**Origination Form**  
Proposed Revisions to a Standard Plans Index

| <b>Originator:</b> | Meyer, Ronald                | <b>Index Number:</b>    | 508-T01                                                 |
| <b>E-mail:</b>     | Ronald.Meyer@dot.state.fl.us | <b>Index Title:</b>     | TRAFFIC CONTROL DEVICES FOR MOVABLE SPAN BRIDGE SIGNALS |

**FIGURE - F**

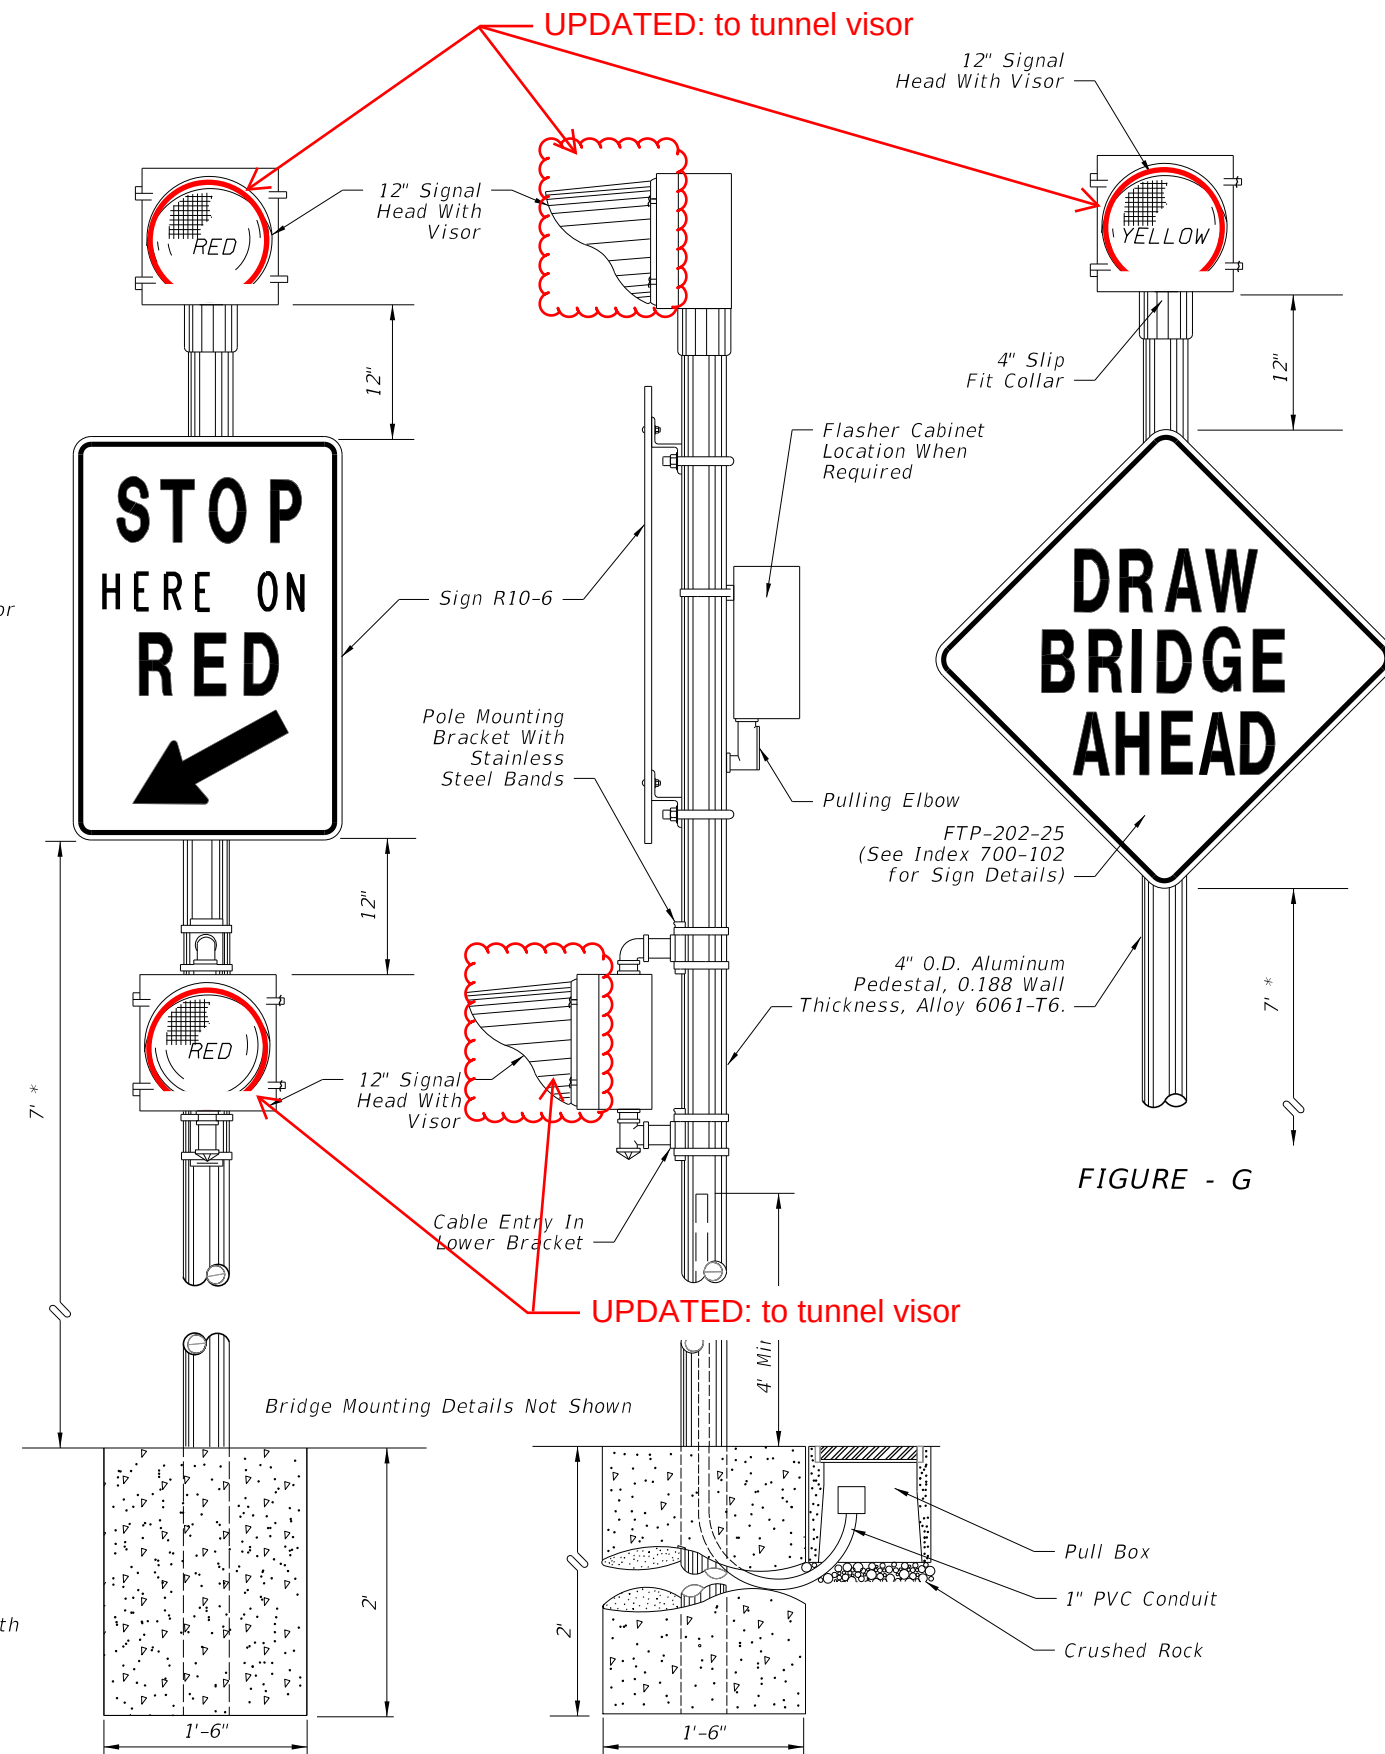
Updated the Signal visor from a Cap type to a Tunnel type in FIGURE - F and FIGURE - G.

The TERL requests that 508-T01 be modified to depict signals with tunnel or full circle visors. Only tunnel or full circle visors are listed on the APL due to requirements for circular traffic signals in sections 650 and 995-4. Signals and beacons typically use tunnel visors due to this specification content as well as depictions of signals and sign beacons throughout other Standard Plans (e.g. 700-120, Sheet 10 of 13 depicting a RR sign with a beacon, etc.).
